**Historic Preservation Services**

## REPORT OF ALTERATIONS TO DESIGNATED RESOURCE Site Number/Address: 200 Jefferson Street / Union Pacific Passenger Depot Old Town National Register Historic District ISSUED: October 18, 2021

200Jef50 & 200Jef78, 200 Jefferson Street in 1950 (left) and 1978 (right), showing chimney with concrete cap and distinctive roof ridge (Fort Collins Museum of Discovery archives).

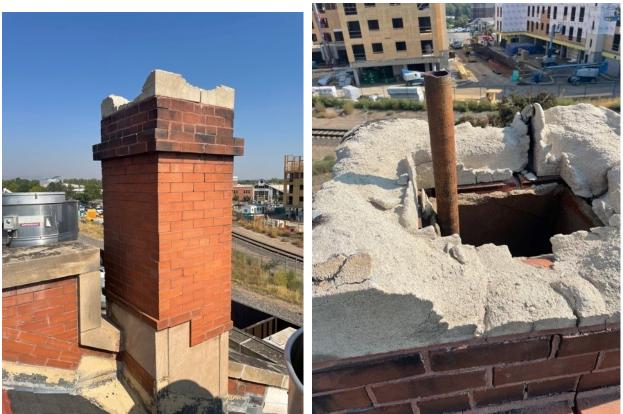
- In-kind roof replacement (asphalt shingle)
- Galvanized metal cap on brick chimney (Pre-Weathered Galvalume style)
- Note 1 Chimney Metal caps on "mothballed" chimneys is a common way to seal them and prevent water infiltration into the building. In-kind replacement of the damaged concrete cap is encouraged; if executed, care should be taken to match existing/historic mortar strengths to avoid long-term damage to the brick and joinery underneath the cap. From submitted photos, repointing of the chimney masonry by a qualified mason appears warranted and is encouraged.
- Note 2 Roof ridge The building includes a distinctive masonry roof ridge that should be retained/preserved as part of the project.
